Auckland Transport
Attention: Have your say, Jonathan Levell, Scott Ebbett

# SUBMISSION TO THE INTRODUCTION OF PAID PARKING IN PARNELL

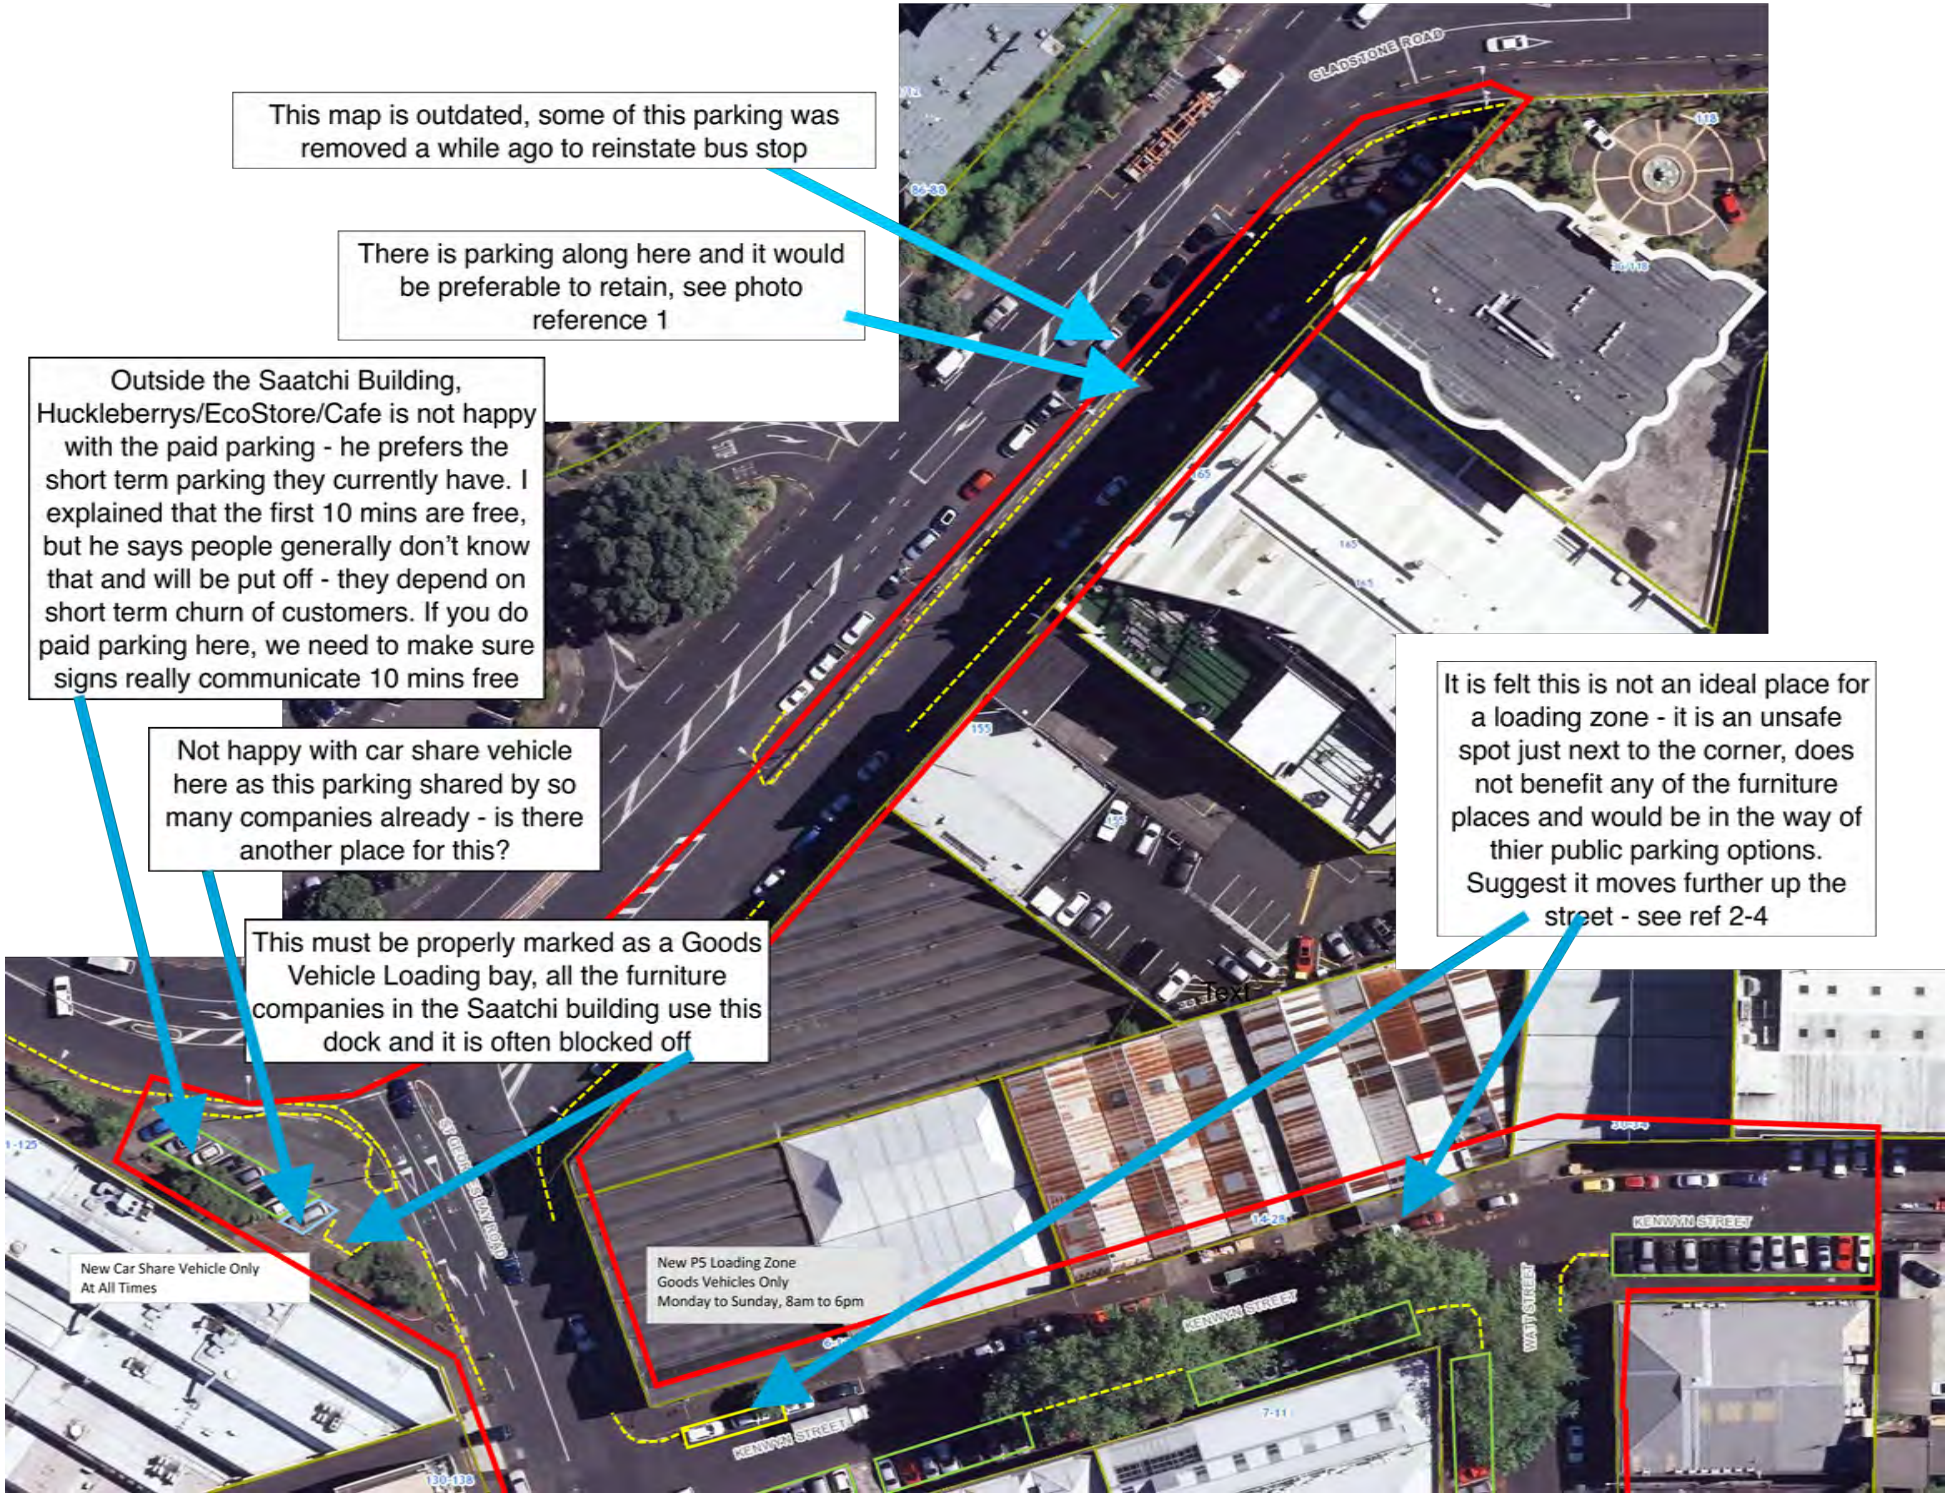
This map is outdated, some of this parking was removed a while ago to reinstate bus stop
There is parking along here and it would be preferable to retain, see photo reference 1
Outside the Saatchi Building, Huckleberrys/EcoStore/Cafe is not happy with the paid parking - he prefers the short term parking they currently have. I explained that the first 10 mins are free, but he says people generally don't know that and will be put off - they depend on short term churn of customers. If you do paid parking here, we need to make sure signs really communicate 10 mins free
Not happy with car share vehicle here as this parking shared by so many companies already - is there another place for this?
This must be properly marked as a Goods Vehicle Loading bay, all the furniture companies in the Saatchi building use this dock and it is often blocked off
It is felt this is not an ideal place for a loading zone - it is an unsafe spot just next to the corner, does not benefit any of the furniture places and would be in the way of thier public parking options. Suggest it moves further up the street - see ref 2-4

1. Parking area on inside of The Strand, needs to be retained

2. Design Warehouse actually load into their premises outside no 14 Kenwyn or via the next roller door

3. This is the footpath between Design Warehouse and IMO. Suggested place for P5 Good Vehicles Loading Zone is here – see ref 4

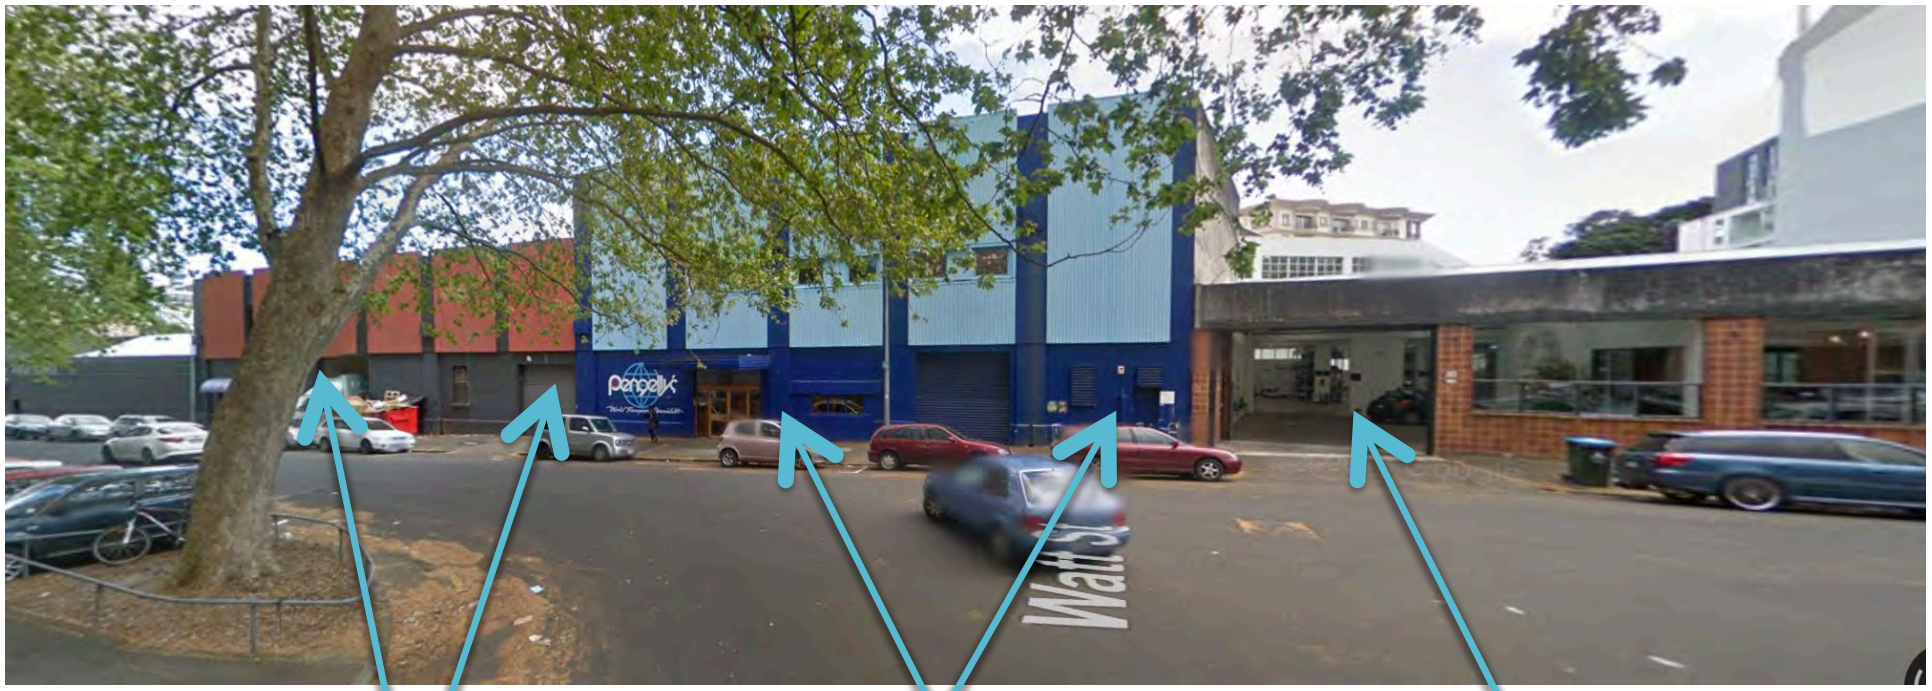
4. Design Warehouse load their goods in these 2 places. Although they have quite big roller doors, there are still trucks that cannot get in and have to offload from the street

Both furniture companies suggested the better place for the P5 Goods Vehicle Loading bay is outside the blue building.

IMO have quite a high entrance, but also have large furniture trucks that do not fit in. They also said they cannot move their forklift along the footpath as it is so broken, so they drive it out of their entrance and the large trucks double parks in the street .

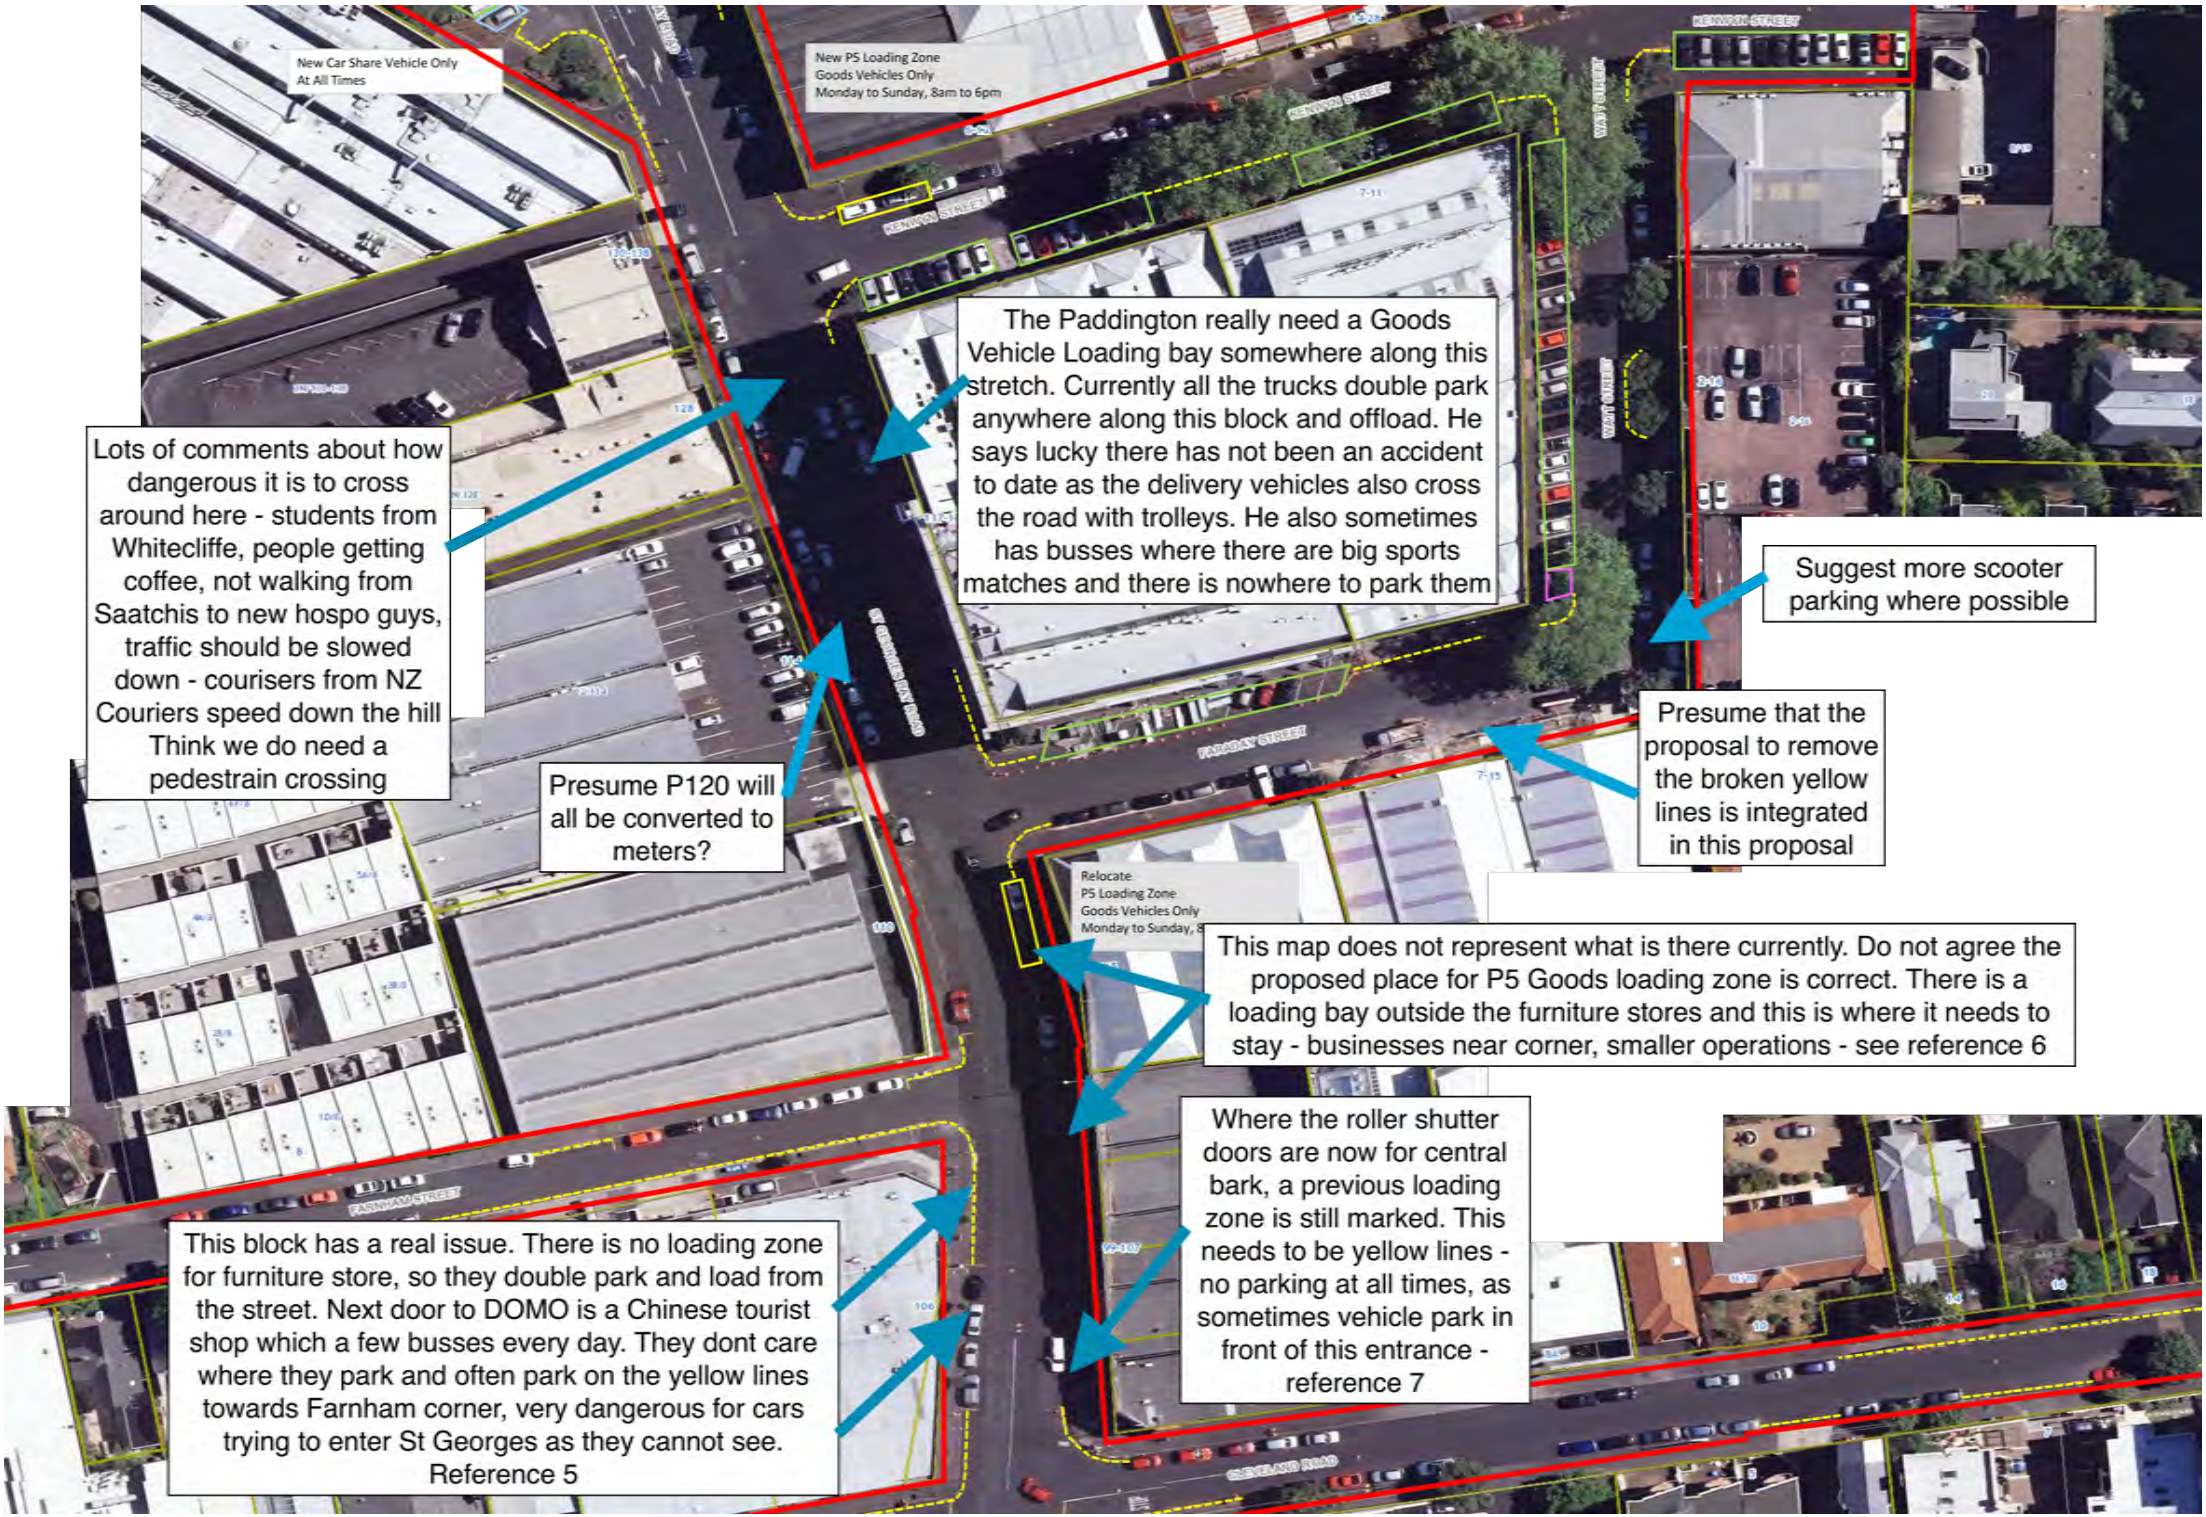
New Car Share Vehicle Only
At All Times
New P5 Loading Zone
Goods Vehicles Only
Monday to Sunday, 8am to 6pm
KENYON STREET
WAY STREET
FARADAY STREET
ST GEORGES BAY ROAD
FARNHAM STREET
CLEVELAND ROAD
Relocate
P5 Loading Zone
Goods Vehicles Only
Monday to Sunday,
The Paddington really need a Goods Vehicle Loading bay somewhere along this stretch. Currently all the trucks double park anywhere along this block and offload. He says lucky there has not been an accident to date as the delivery vehicles also cross the road with trolleys. He also sometimes has busses where there are big sports matches and there is nowhere to park them
Lots of comments about how dangerous it is to cross around here - students from Whitecliffe, people getting coffee, not walking from Saatchis to new hospo guys, traffic should be slowed down - courisers from NZ Couriers speed down the hill Think we do need a pedestrain crossing
Suggest more scooter parking where possible

Presume P120 will all be converted to meters?
Presume that the proposal to remove the broken yellow lines is integrated in this proposal
This map does not represent what is there currently. Do not agree the proposed place for P5 Goods loading zone is correct. There is a loading bay outside the furniture stores and this is where it needs to stay - businesses near corner, smaller operations - see reference 6
Where the roller shutter doors are now for central bark, a previous loading zone is still marked. This needs to be yellow lines - no parking at all times, as sometimes vehicle park in front of this entrance - reference 7
This block has a real issue. There is no loading zone for furniture store, so they double park and load from the street. Next door to DOMO is a Chinese tourist shop which a few busses every day. They dont care where they park and often park on the yellow lines towards Farnham corner, very dangerous for cars trying to enter St Georges as they cannot see. Reference 5

Reference 5 for outside DOMO furniture store. No loading zone and busses park illegally here

Reference 6 - This is a new marked loading zone and needs to stay here

Previous loading zone where vehicles are parking and blocking off the entrance
